ROCHESTER GAS & ELECTRIC CORPORATION

**Subject:** Technical Requirements Manual (TRM) Revision 18

TRM sections TR 3.7.7, Spent Fuel Pool (SFP) Cooling System, and TR 3.9.4, Full Core Offload for Cycle 27, will be revised to provide the changes associated with PCR 2001-0036 and the Cycle 29 core offload. PCR 2001-0036 provides the ability to cross-tie the A SFP pump and/or the Standby SFP pump to the B SFP heat exchanger. Analysis has been generated supporting the timing of the Cycle 29 core offload.

# Technical Requirements Manual TRM

Figure TRB 3.7.7-1  
SFP Cooling System

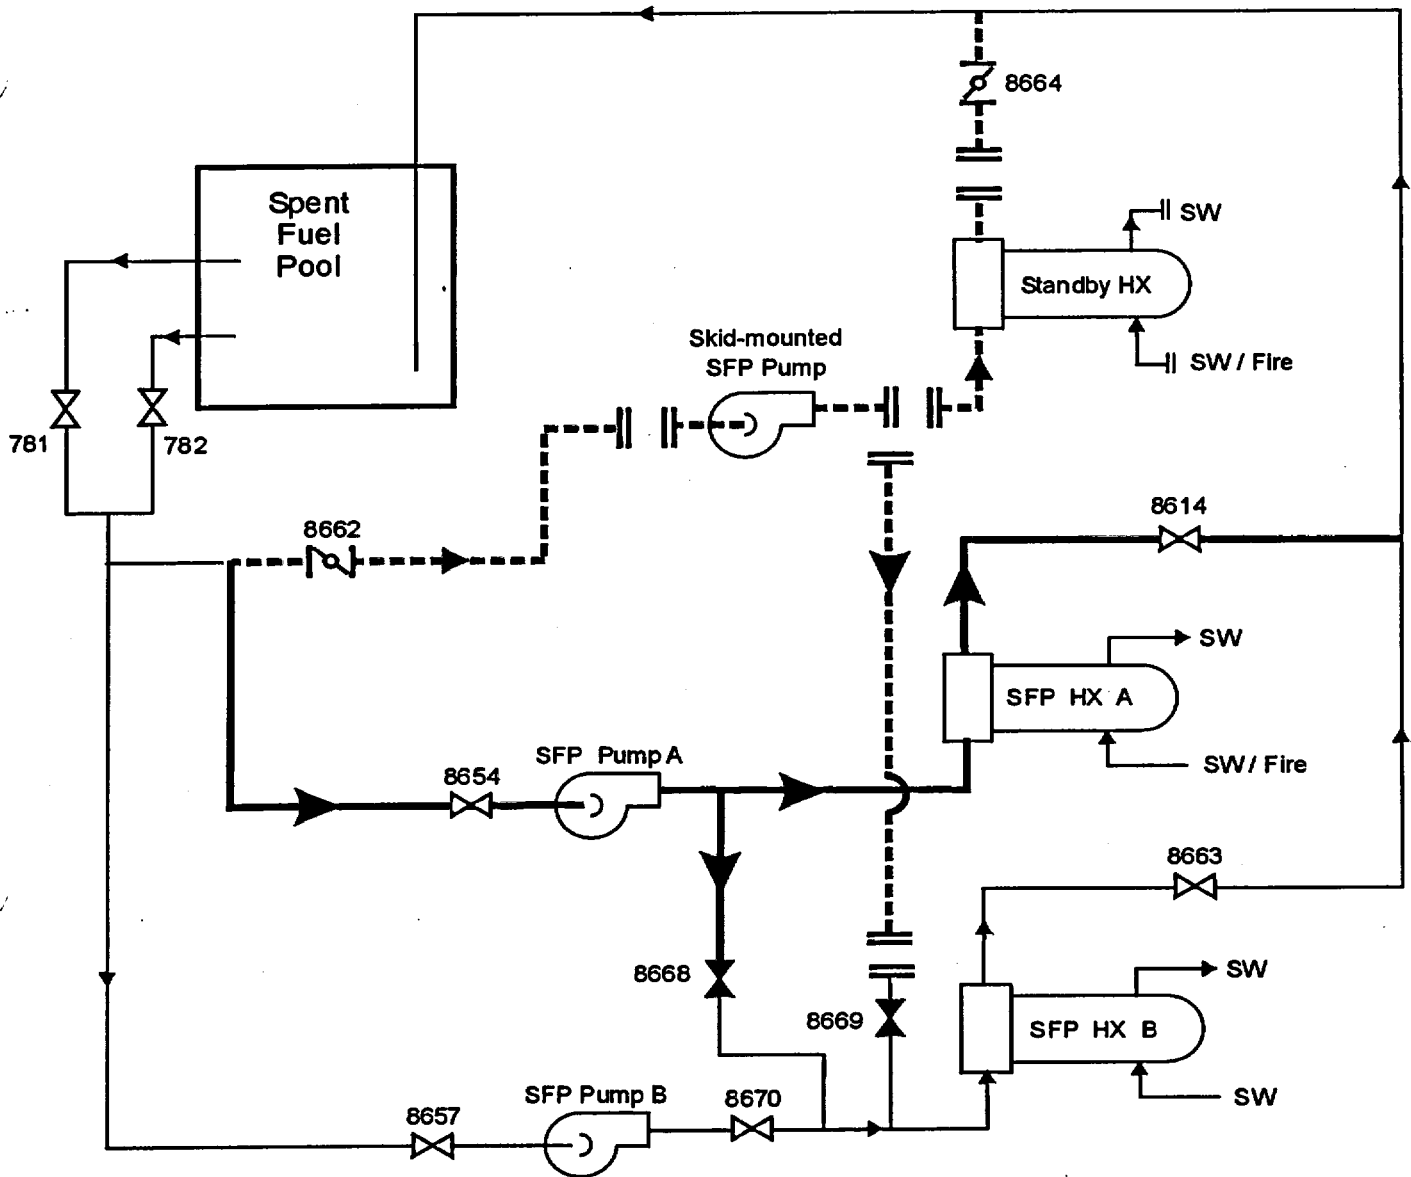
The SFP Cooling System consists of three SFP pumps, two installed SFP heat exchangers, one SFP Standby Heat Exchanger (which is not normally used), and associated piping, valves, and hoses (see Figure TRB 3.7.7-1). The flow path starts at the common suction from the spent fuel pool to the three SFP pumps, through one or more SFP pumps and one or more SFP heat exchangers, and to the spent fuel pool via the common return line. The primary loop (SFP Loop B) is made up of the SFP Pump B, SFP Heat Exchanger B, and piping. The backup loops include:

There is also the ability to align the SFP Pump A and SFP Standby Pump individually or in parallel to the SFP Heat Exchanger B. Service water (SW) circulates through the shell while SFP water circulates through the tubes of the SFP heat exchangers. There is also the ability to provide fire water for cooling of the SFP Heat Exchanger A and SFP Standby Heat Exchanger. SFP Cooling System Loop B is sized for 100% of the design SFP heat load. SFP Loop A and the SFP Standby Loop are each capable of removing the normal basis heat load. When the SFP Pump A and the SFP Standby Pump are operated in parallel, through either their designated heat exchangers or through the SFP Heat Exchanger B, they can remove 100% of the design heat load (Ref. 1). Motor-operated valves provide automatic and remote manual isolation of the SW supply to the SFP heat exchangers. These valves close automatically upon coincidence of safety injection and loss of offsite power. Handwheels are provided for manual operation.
